Access Compliance Report

Public Rights-of-Way (Curb Ramps)

Intersection ID: 53425	Main Street: HOUSTON_FIELD_CT	Cross Street: PROVIDENCE_RD	Location: NE
ADA ID: 5B7BD50F42F6	Ramp Type: Perp	Initial Pass/Fail: Fail	Overall Compliance: No
Severity Score: 21.25			
Codes/Mitigation Info/Possible Solution		Field Measurements/Component Compliance

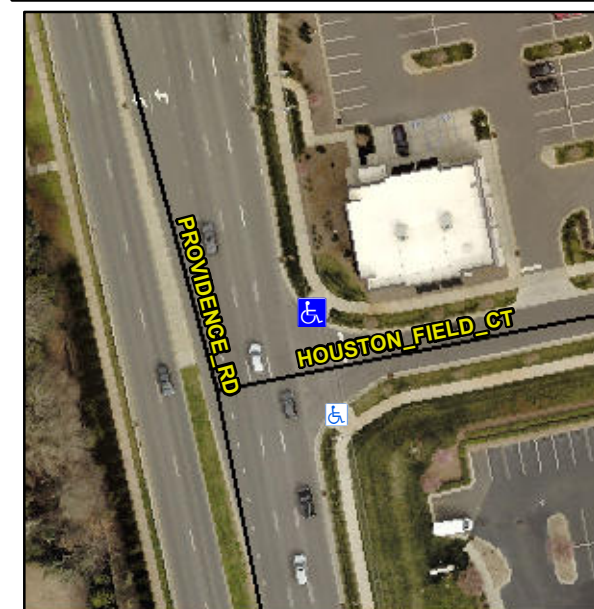
Not Found, R304.5.1, R304.2.2

Compliance	Description	Data	Compliance	Description	Data
N/A	Ramp Length (in)	96.5	No	Ramp Slope (%)	8.6
No	Ramp Width (in)	47.5	Yes	Ramp XSlope (%)	0.7
N/A	Flare Type LT	N/A	N/A	Flare Type RT	N/A
N/A	Flare Slope LT (%)	N/A	N/A	Flare Slope RT (%)	N/A
N/A	Flare Traversable LT?	N/A	N/A	Flare Traversable RT?	N/A
N/A	Landing Length (in)	N/A	N/A	DWS Provided?	N/A
N/A	Landing Width (in)	N/A	N/A	DWS Contrast?	N/A
N/A	Landing Slope (%)	N/A	N/A	DWS Length (in)	N/A
N/A	Landing X Slope (%)	N/A	N/A	DWS Full Width?	N/A
N/A	Landing Curb? (Y/N)	N/A	N/A	DWS Offset (in)	N/A
N/A	Shared Landing?	N/A			
N/A	Gutter Ponding?	N/A	N/A	Gutter Slope (%)	N/A
N/A	Gutter Lip Ht (in)	N/A	N/A	Gutter X Slope (%)	N/A
N/A	Painted X Walk1?	No	N/A	Painted X Walk2?	N/A
	X Walk 1 Direction	To S		X Walk 2 Direction	N/A
N/A	X Walk 1 Width (in)	N/A	N/A	X Walk 2 Width (in)	N/A
	X Walk 1 Slope (%)	2.7		X Walk 2 Slope (%)	N/A
	X Walk 1 X Slope (%)	0.4		X Walk 2 X Slope (%)	N/A

Remove & Replace Entire Ramp.
